Doc. ID: PA-003-191001-003-01

Urgent Field Safety Notice

PA-003, c4D Software application v 5.4.2 and earlier, Catalyst and Catalyst HD client with C-RAD Gating Box HZ-009, used for gating on Varian C-Series accelerators

Subject: No beam control if Gating box HZ-009 loses power during treatment

Figure 1, Gating Box bypassed GUI indication.

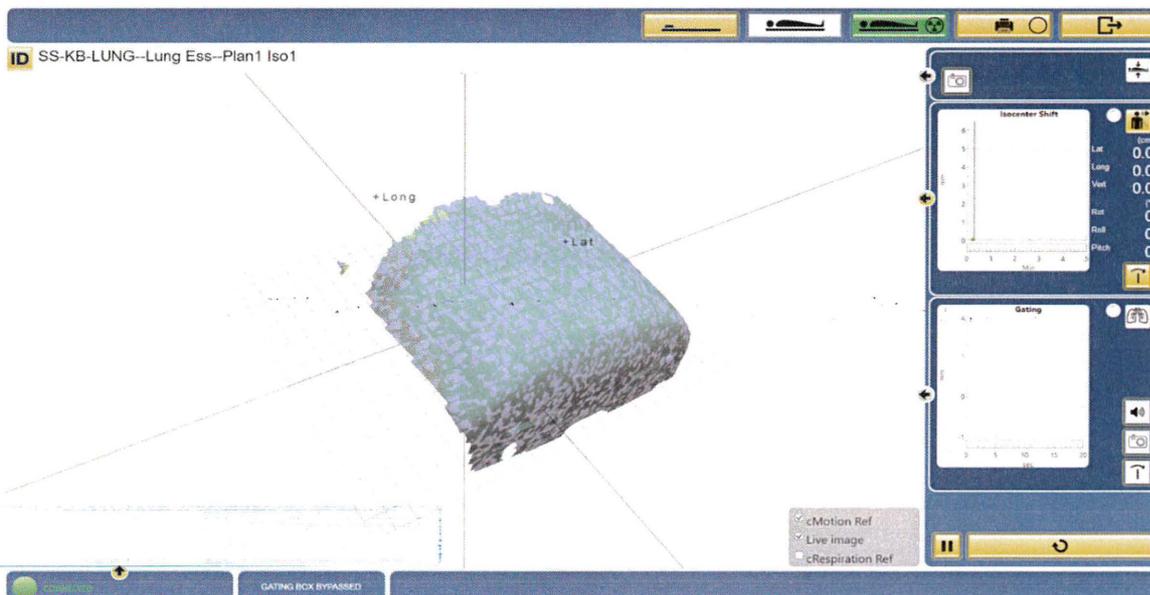
If the gating box is disconnected from power c4D will display a status indicating that gating is bypassed, see Figure 1. (the status "GATING BOX BYPASSED" is shown both when the switch box key is switched off, or regardless of key switch status if the gating box is disconnected from power)

If the user continues the treatment after this message is displayed, the treatment can proceed without the beam being gated. The situation is equivalent to the switch box key being switched to off. Treating the plan without gating may lead to mistreatment and patient harm.

As an immediate action affected customers should ensure to use a common power source for the Catalyst Client computer and the Gating Box HZ-009. A power failure to this power line will then also stop the C-RAD side of the communication link, causing the Varian Linac side to pull an interlock.
